# Access Compliance Report

## Public Rights-of-Way

Intersection ID: 47116	Main Street: MCKEE_FOREST_CT	Cross Street: CARPENTER_CABIN_DR	Location: SE
ADA ID: D63094D9C2A0	Ramp Type: PerpDiag	Initial Pass/Fail: Fail	Overall Compliance: No
		Severity Score: 12.5

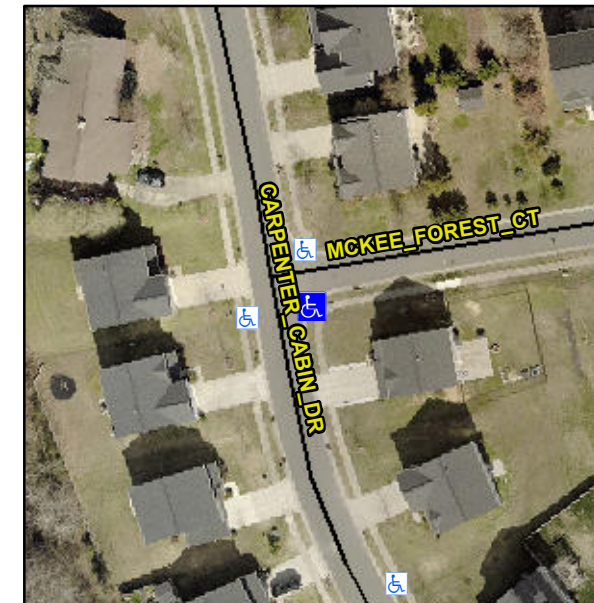
**Not Found, R304.5.3**

Compliance	Description	Data	Compliance	Description	Data
N/A	Ramp Length (in)	48.0	Yes	Ramp Slope (%)	5.1
Yes	Ramp Width (in)	48.0	No	Ramp XSlope (%)	5.2
N/A	Flare Type LT	N/A	N/A	Flare Type RT	N/A
N/A	Flare Slope LT (%)	N/A	N/A	Flare Slope RT (%)	N/A
N/A	Flare Traversable LT?	N/A	N/A	Flare Traversable RT?	N/A
N/A	Landing Length (in)	N/A	N/A	DWS Provided?	N/A
N/A	Landing Width (in)	N/A	N/A	DWS Contrast?	N/A
N/A	Landing Slope (%)	N/A	N/A	DWS Length (in)	N/A
N/A	Landing X Slope (%)	N/A	N/A	DWS Full Width?	N/A
N/A	Landing Curb? (Y/N)	N/A	N/A	DWS Offset (in)	N/A
N/A	Shared Landing?	N/A			
N/A	Gutter Ponding?	N/A	N/A	Gutter Slope (%)	N/A
N/A	Gutter Lip Ht (in)	N/A	N/A	Gutter X Slope (%)	N/A
N/A	Painted X Walk1?	No	N/A	Painted X Walk2?	No
	X Walk 1 Direction	To N		X Walk 2 Direction	To W
N/A	X Walk 1 Width (in)	N/A	N/A	X Walk 2 Width (in)	N/A
	X Walk 1 Slope (%)	4.6		X Walk 2 Slope (%)	2.1
	X Walk 1 X Slope (%)	1.0		X Walk 2 X Slope (%)	5.1

**Remove & Replace Curb Ramp With Two New Directional Ramps or Equivalent.**
